DESIGN STANDARDS BULLETIN

Appendix M – Building Signage

Revise sign types J, K and K.1 per the attached.

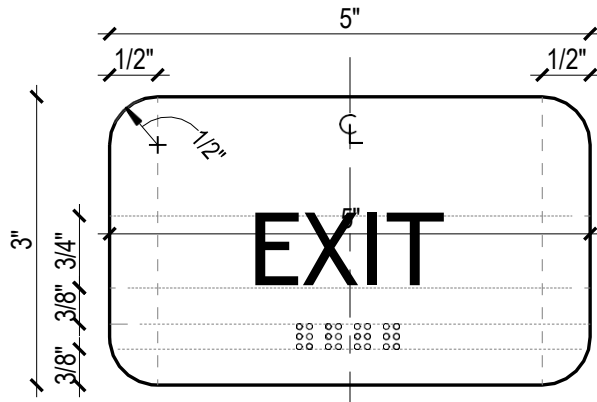
Signage in the exit stairwells, Sign Type K was incorrect per the current code.
